**City Planning Commission
Meeting – May 26, 2015**

**CONSIDERATION – SUBDIVISION DOCKET – 052/15
Applicants: Cindy M Mandina, Claus L Grassel, Robert E Eisterhold**

Prepared By: Brittany DesRocher
Date: May 13, 2015
Deadline: June 9, 2015

A Resubdivision of Lots 89 & 91 of Park Place Sub., &
Lots 3, 2, & Pt. 1 of Sq. "B", Homedale Annex into
Lots 89A & 91A of Park Place Sub.

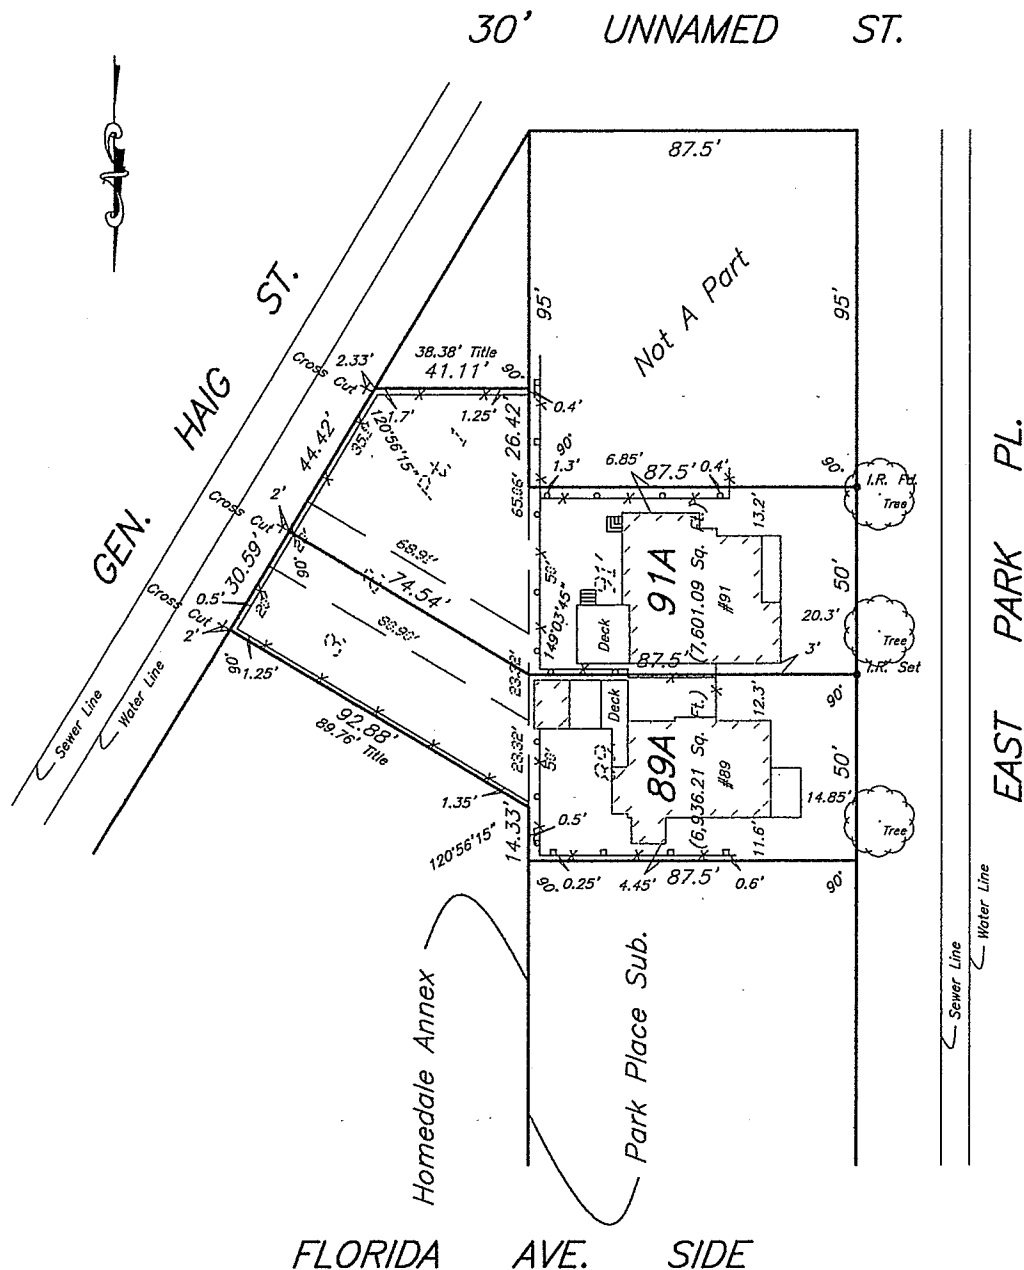
The representative of the Sewerage and Water Board stated that subsurface drainage was available but not shown. They also noted that sewer and water facilities are available but not shown on the survey, and recommended that a note should be shown on the subdivision plans stating that sewer and water house connections are the responsibility of the property owner.

Pursuant to **Article 9A, Section 9A.1.7 (Table 9A.A)** of the Comprehensive Zoning Ordinance, the minimum lot width required for a single-family residence is forty (40) feet, the minimum lot depth required is ninety (90) feet, and the minimum lot area required is five thousand (5,000) square feet. Proposed Lot 89A and Lot 91A would both meet the minimum lot depth requirement of the LRS-1 District, measuring approximately one hundred seventy-one (171) feet and one hundred forty-five (145) feet, respectively. Both proposed lots would also meet the minimum lot area having an area of six thousand nine hundred thirty-six and twenty-one hundredths (6,936.21) square feet and seven thousand six hundred one and nine hundredths (7,601.09) square feet. Proposed lot 91A would meet the minimum lot width requirement along General Haig Street measuring forty-four and forty-two hundredths (44.42) feet. However, proposed lot 89A would be deficient in lot width because the new frontage on General Haig Street would only measure thirty and fifty-nine hundredth (30.59) feet. Historically the three (3) existing lots that front General Haig Street were developed with a single family residence that met the width and area requirements of the LRS-1 District but was deficient in lot depth with a depth of approximately sixty-seven (67) feet. Parcels with insufficient lot depth are much more common in this area than lots with insufficient lot width. The staff believes that in regard to lot depth and lot area, the proposed lots would be are a significant variation from the typical lot pattern of the surrounding area.

The proposed lots do not meet the minimum lot width of 40 feet in Article 5, Section 5.5.1 Lot Size of the New Orleans Subdivision Regulations. Additionally, the proposed lots would be double frontage lots. Article 5, Section 5.5.5 Double Frontage Lots of the Subdivision Regulations discourages the creation of double frontage lots except in instances that meet one of the following criteria:

The proposed subdivision does not involve a major street, so the first criterion does not apply. There is only one example of a double frontage lot in the surrounding blocks that were surveyed by staff and appropriate off-street parking and fire access already exist therefore the second criterion does not apply. Since the proposed subdivision does not meet the double frontage lot criteria, this case must be considered by the City Planning Commission.

Subdivision Docket 052/15 is a request to resubdivide Lots 89, 91, 3, 2 and Pt Lot 1 into Lots 89A and 91A, which would create (2) double frontage lots, one with insufficient lot width. In addition to lot 89A having insufficient width, the proposal fails to meet two of the criteria stipulated under Article 5, Section 5.5.5 Double Frontage Lots of the Subdivision Regulations, and therefore requires approval of the City Planning Commission. The proposal fails to meet the first criterion because it doesn't involve a major street. The second criterion wasn't met because there is not a pattern of double front lots in the area and appropriate off-street parking and fire access already existed on the developed lots.

The staff recommends **DENIAL** of Subdivision Docket 052/15.

1. The creation of two (2) irregularly shaped double frontage lots, one (1) with insufficient lot width, would create a condition that would inhibit future development and use of the subject properties.
2. The proposal does not meet the two criteria of Article 5, Section 5.5.5 Double Frontage Lots of the Subdivision Regulations.
